Project #19-025
Vrugg Holdings Westfield Warehouse
Located at 130 South 1100 West

Project Name: Vrugg Holdings Westfield Warehouse
Proponent / Owner: Hal Fronk
Project Address: 130 South 1100 West
Request: Design Review Permit
Current Zoning: Commercial Service (CS)
Type of Action: Quasi-Judicial
Hearing Date: August 8, 2019
Submitted By: Russ Holley, Senior Planner

Staff recommends that the Planning Commission **conditionally approve** a Design Review Permit for Project #19-025, Westfield Warehouse, in the Commercial Service (CS) zone located at 130 S 1100 West, TIN #05-107-0019.

1	Site Plan Concept
100A	1" = 100'-0"

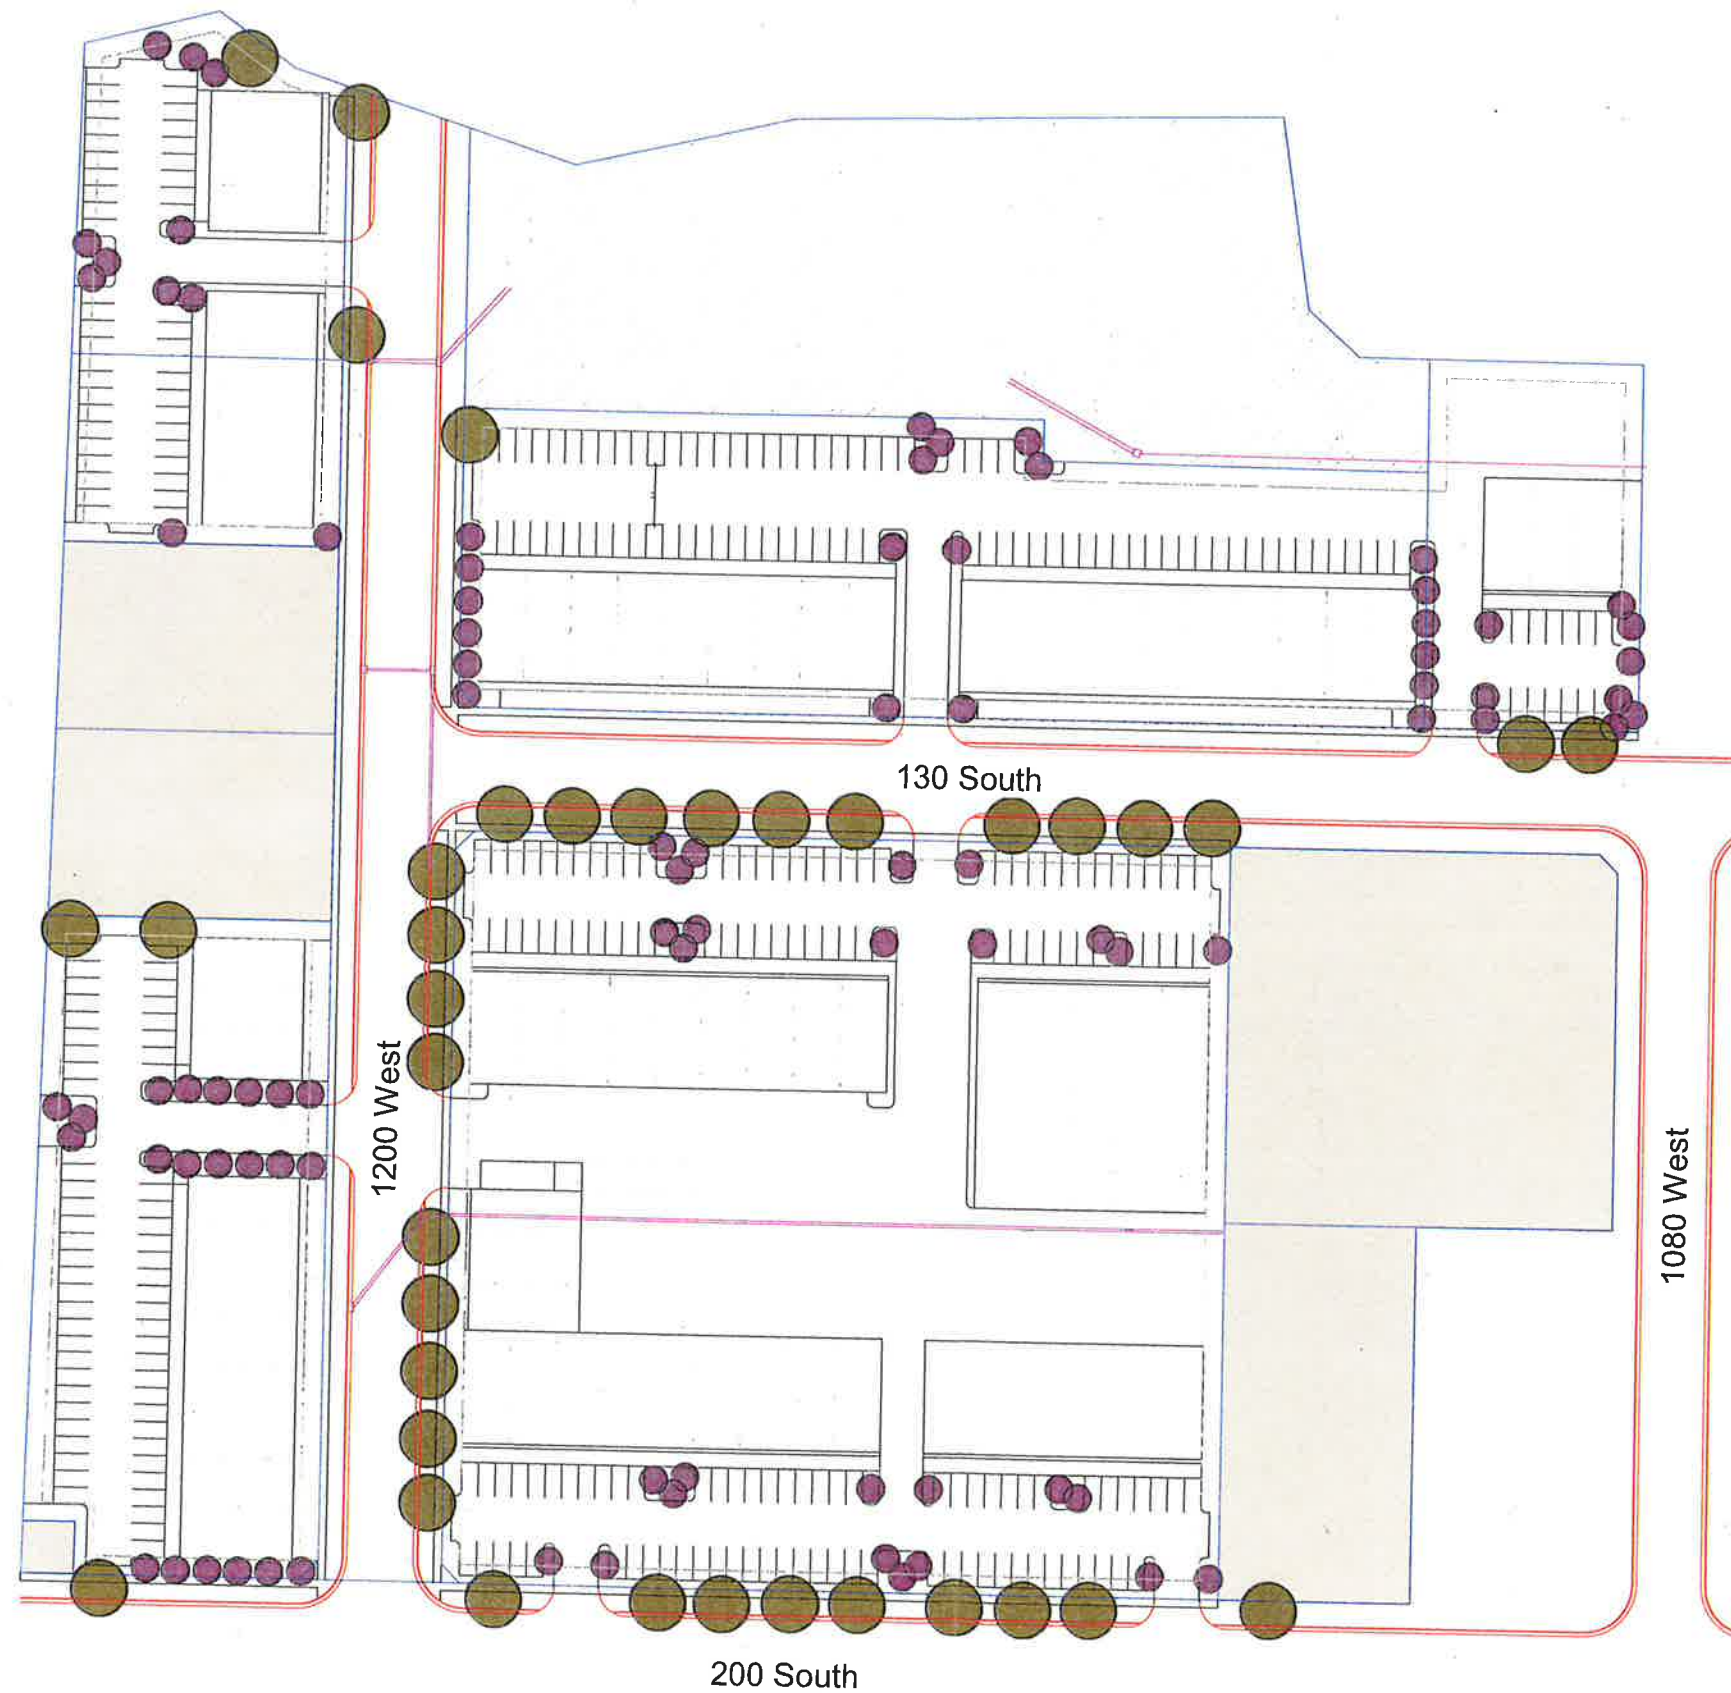
As proposed, there are setback violations for parking lots and buildings adjacent/opposite the NR zoned areas to the south. The project does not account for the additional or enhanced setback requirements adjacent to NR zones. As conditioned with additional setbacks in these areas, the project meets minimum setback requirements of the LDC.

The project proposes buildings with front facing facades and walkways connecting to the street. Five (5) of the buildings are located behind front-yard parking lots, something that is now prohibited in the CS zone. There are a few existing buildings in this development with front-yard parking lots that were built prior to the 2016 code change prohibiting front yard parking lots in the CS zone. As conditioned with building orientation towards the street and parking lots located in the rear or side yard, the project meets the requirements in the LDC.

3. All buildings adjacent to the NR zones along 200 South shall have a front yard setback of 25' and any parking areas allowed adjacent to the NR zoning shall have an additional 10' setback.

4. Parking lots shall be located in the rear or side yards as per LDC 17.10.120.
5. Parking requirements shall be reviewed and approved based on each individual business license. For a building permits to be approved, at least 3.0 parking stalls shall be provided per unit located within the building.

1	Typical Front Elevation
201	1" = 20'-0"

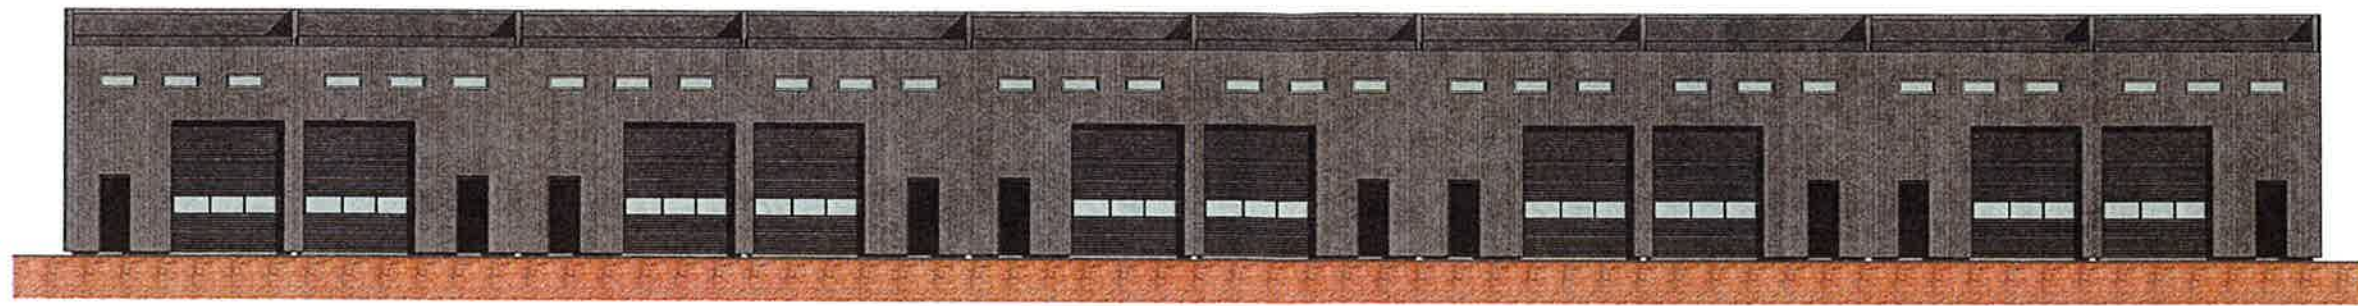
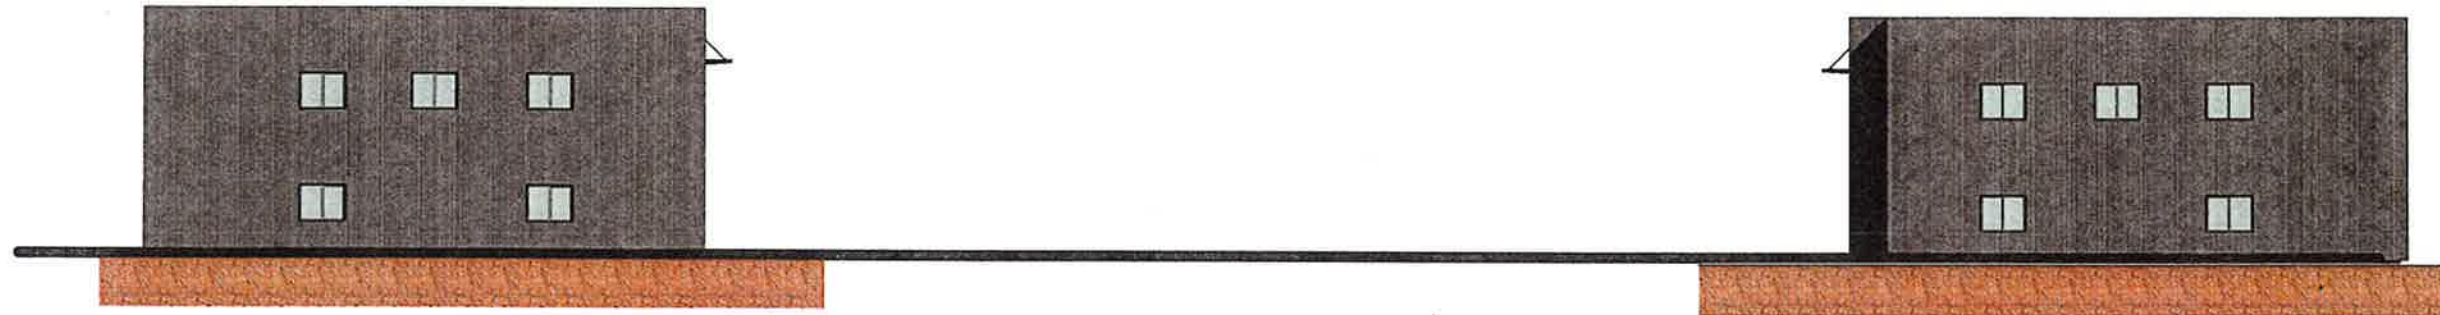
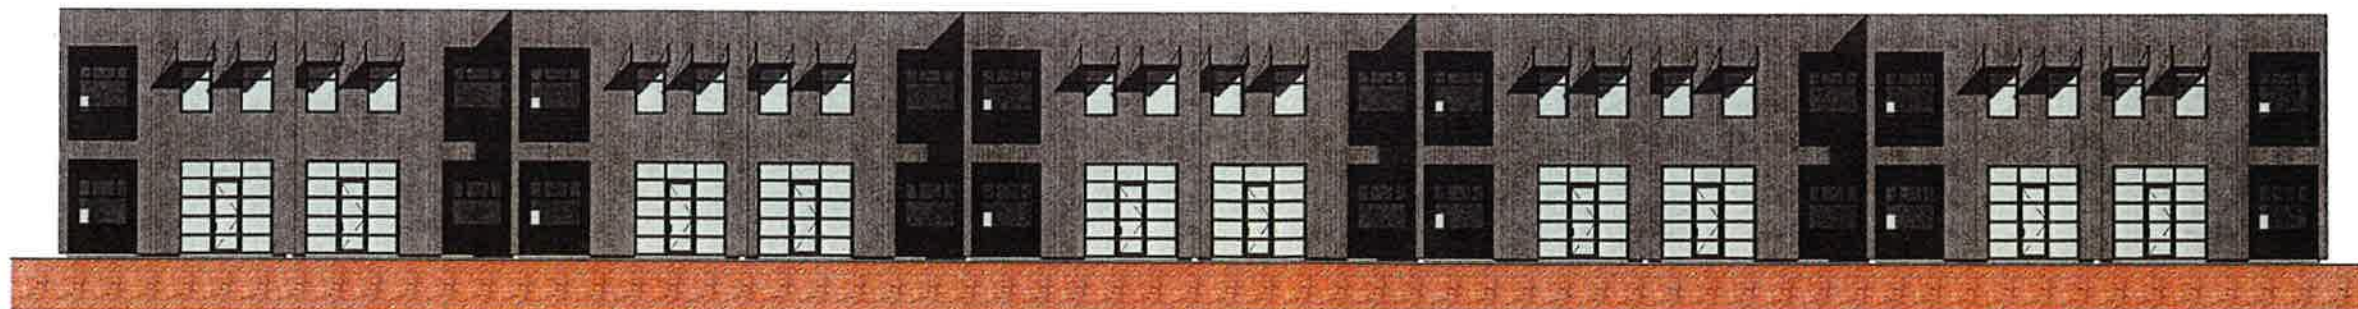
The LDC 17.12.060 indicates that blank walls exceeding 40 linear feet are prohibited. Acceptable breaks include windows, balconies, wall articulation or changes in color or materials. The steel building facades are proposed with wood accent articulation areas and upper floor balconies and windows that meet blank wall code requirements. The LDC also requires a minimum of 30% transparency on ground floor street facing facades. As conditioned with minimum wall breaks and transparencies, the project meets the requirements in the LDC.

8. 30% transparency on the front façade and minimum wall breaks every 40 linear feet shall be required.
9. All public pedestrian entrances shall have weather protection provided.
